design west | architects

date:	5.17.24
project:	Nibley Middle School
by:	Michael Rigby
subject:	Addendum 03

CONTRACT ADDENDUM 03

E-623 – Level 2 – Area C – Intercom:

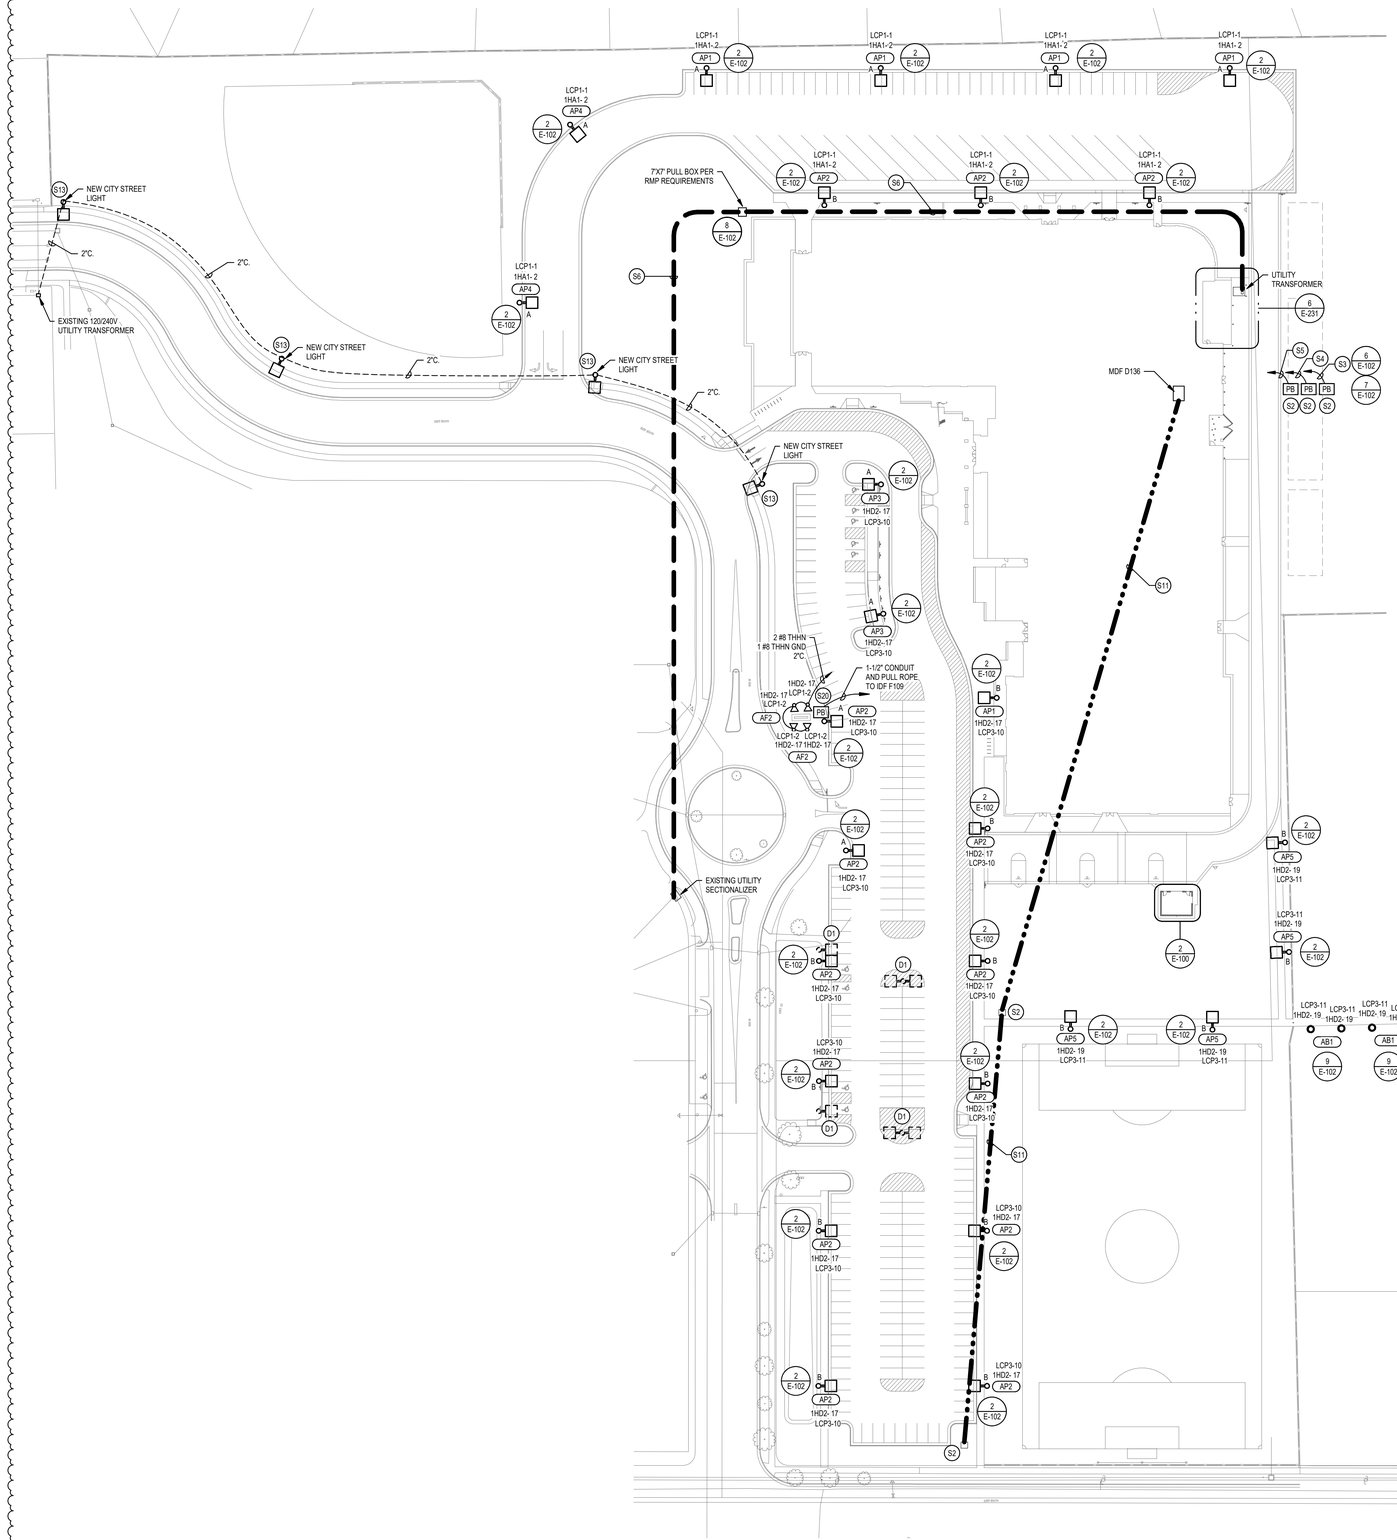
1. Intercom speakers have been modified. See drawings for changes.
